ADDENDUM NO. 02

CLOVIS COMMUNITY COLLEGE SPORTS COMPLEX
Fresno, CA 93730
2425-22

DARDEN PROJECT NO. 2175
DSA File Nos. 10-C3
DSA APPL. NO. 02-122242

The following additions, deletions, and revisions to the SHEETS and Project Manual are hereby made and do become a part of these Contract Documents.

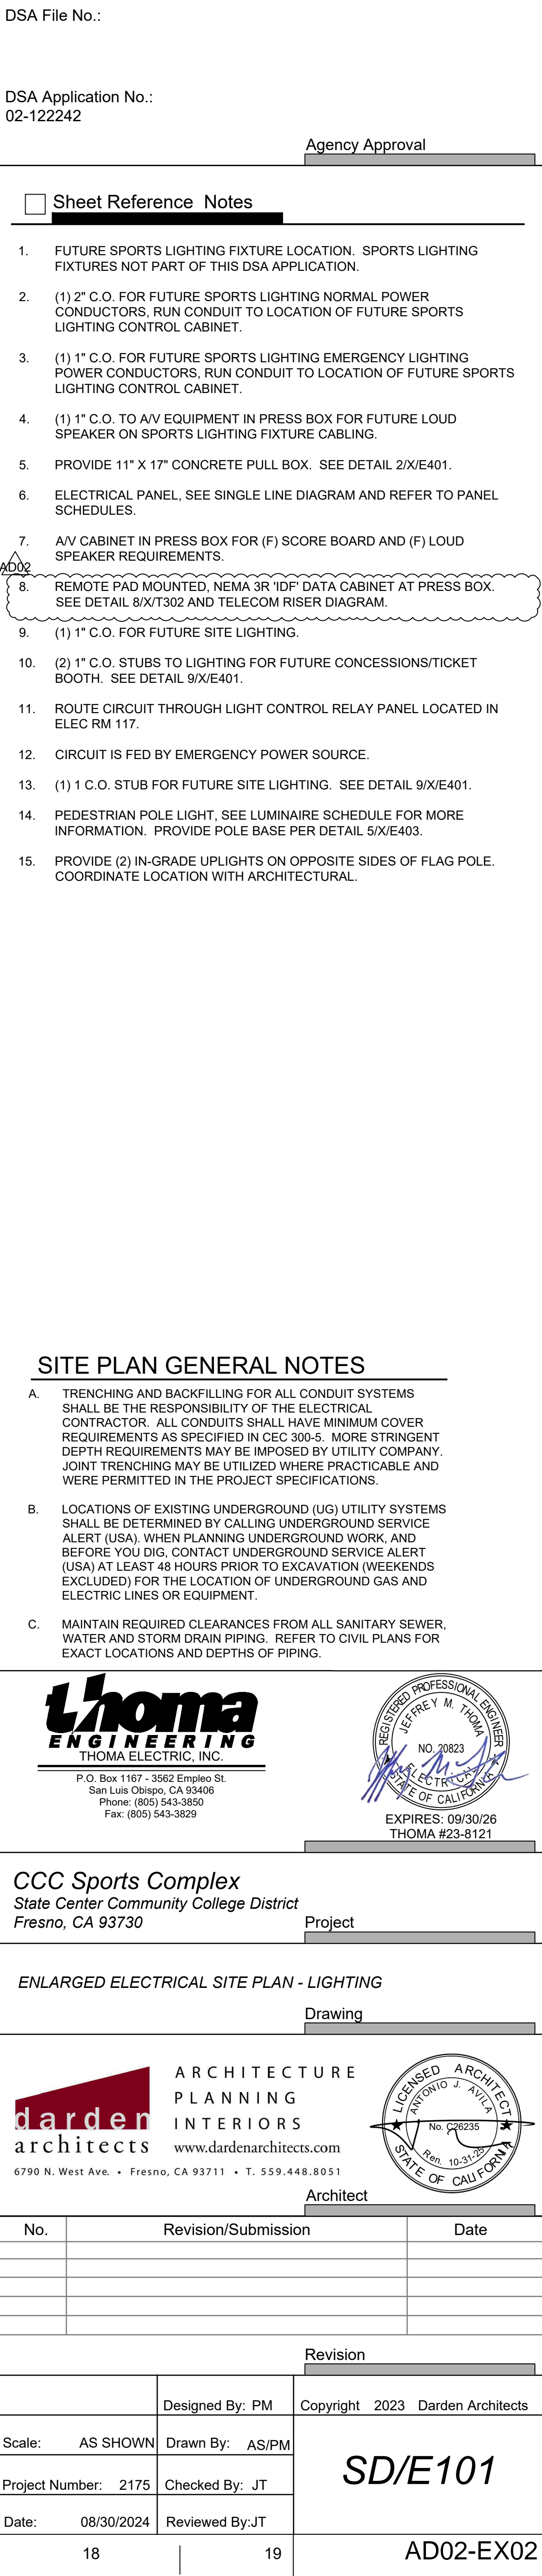
AD02-E01 Refer to Sheet X/E202, and attached drawing AD02-EX01:

1. Refer to panel schedule 2E1. Added dedicated circuits 13 & 15 for remote IDF cabinet.

ENLARGED ELECTRICAL SITE PLAN, POWER / TELECOM

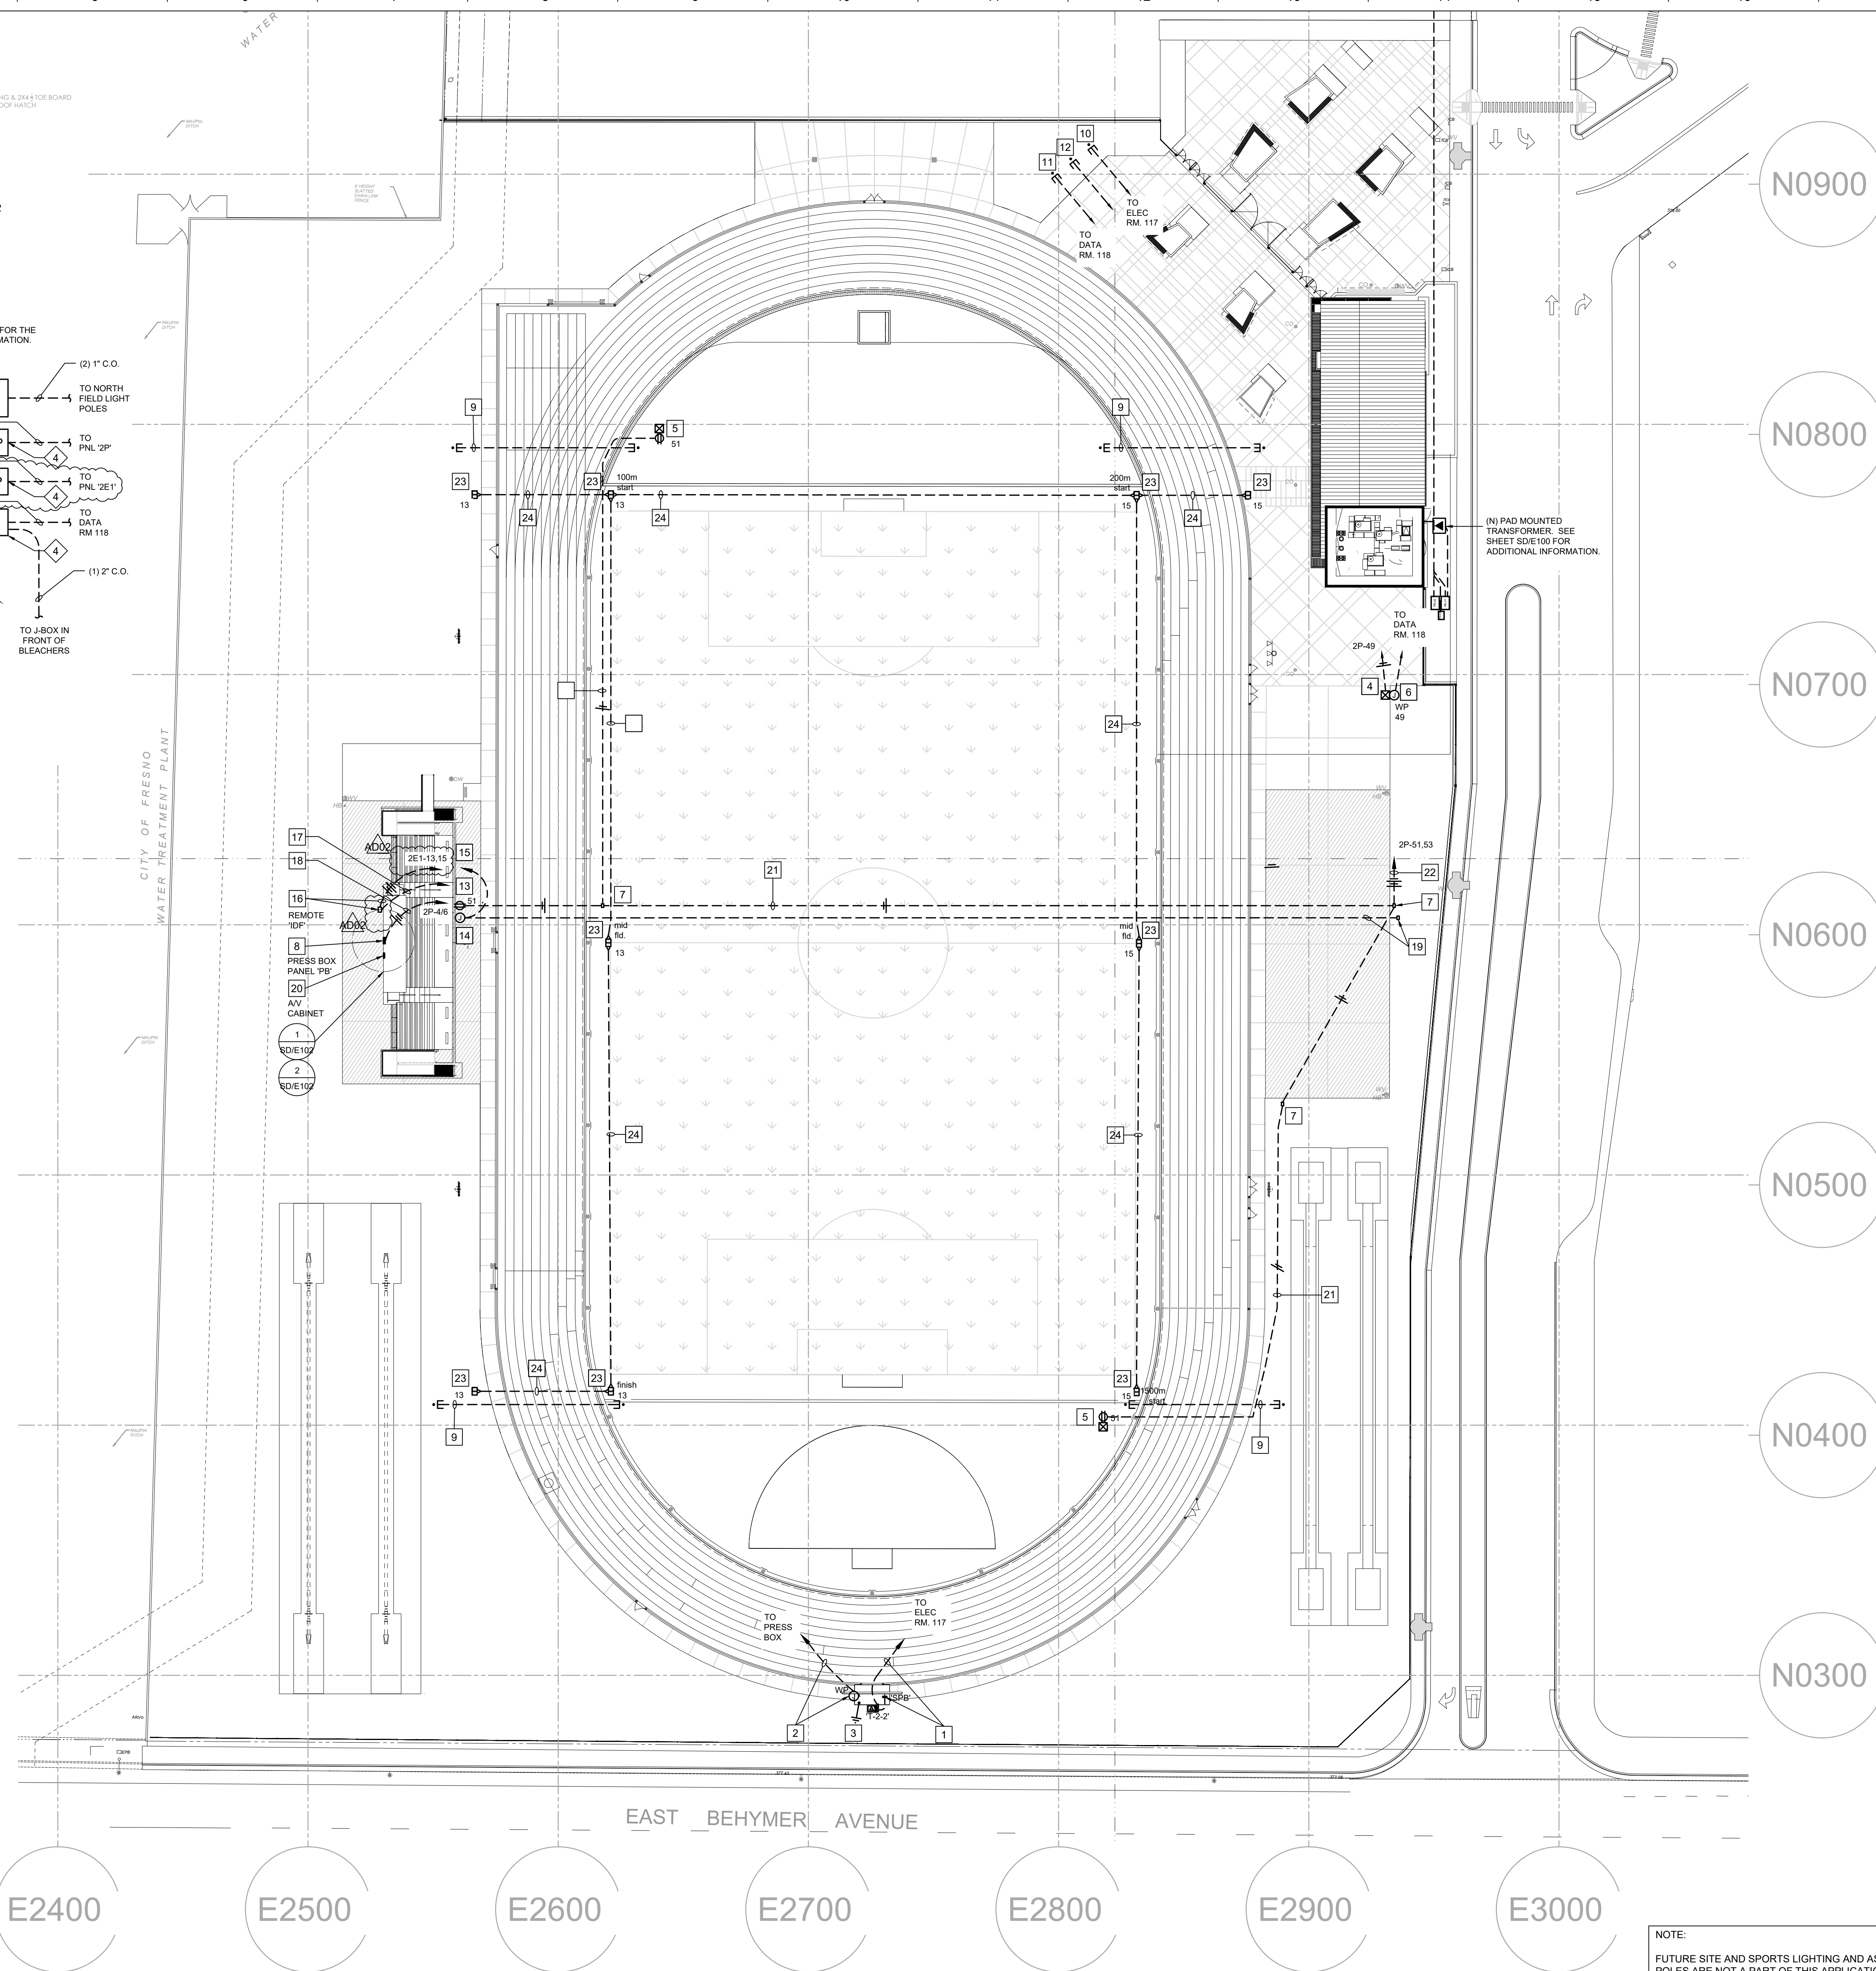
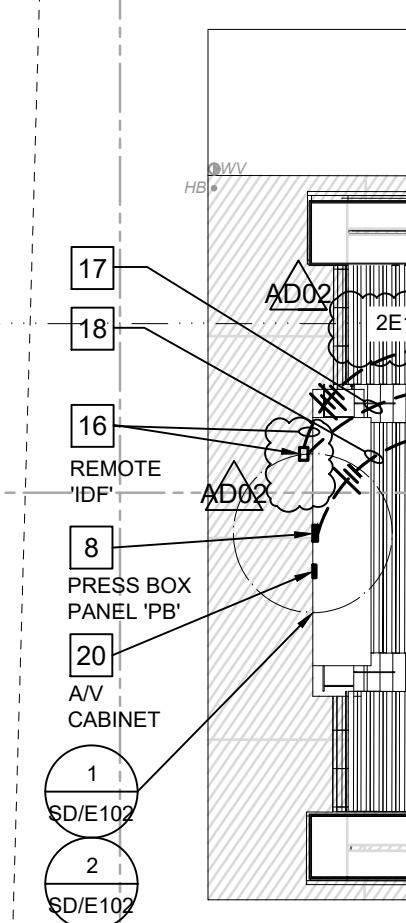
AD02-E03 Refer to Sheet SD/E102, and attached drawing AD02-EX03:

1. Refer to Site Plan. Relocated Press Box IDF cabinet.
2. Refer to Site Plan. Added emergency power circuits 2E1-13 &15 for remote IDF cabinet.
3. Refer to Site Plan Reference Notes. Modified reference notes 16 and 17.
4. Refer to detail 2/SD/E102. Added two exterior building mounted wireless access points.
5. Refer to detail 1/SD/E102. Relocated IDF cabinet and changed to pad mounted NEMA 3R enclosure.
6. Refer to detail 1/SD/E102. Added emergency power pullbox, conduit, and circuits for remote IDF cabinet.

7. Refer to detail 1/SD/E102. Added communications J-box at press box.
8. Refer to detail 1/SD/E102. Modified A/V conduit callout.
9. Refer to Press Box reference notes. Added references notes 6 and 7. Modified reference notes 2 and 4.

1. PROVIDE A MINIMUM 24" X 24" X 6" J-BOX FOR PRESS BOX A/V CABLING.
2. REMOVE PAD MOUNTED, NEMA 3R IDF CABINET. SEE DETAIL 8/R/T302 AND COORDINATE WITH TELECOM RINGS DIAGRAM FOR REQUIREMENTS.
3. PROVIDE A MINIMUM 2' X 3' CONCRETE PULL BOX FOR A/V CABLING.
4. PROVIDE A MINIMUM 17' X 30" CONCRETE PULL BOX FOR POWER CIRCUITS AND DATA CABLING.
5. PROVIDE FIELD TIMING SYSTEM CIRCUIT CONTROL SWITCHES, 20A 3-P 5T, IN COORDINATION WITH SITE POWER PLAN REF. NO. 25. FIELD COORDINATE LOCATION OF SWITCHES. LABEL THE SWITCH WITH CIRCUIT NUMBER AND USE.
6. EXTERIOR W/P. WALL MOUNTED WIRELESS ACCESS POINT. SEE DETAIL 2/X/T301. COORDINATE FINAL LOCATION WITH COLLEGE I.T. REPRESENTATIVE.
7. PROVIDE A MINIMUM 24" X 24" X 6" J-BOX FOR PRESSBOX COMMUNICATION CABLING DISTRIBUTION.
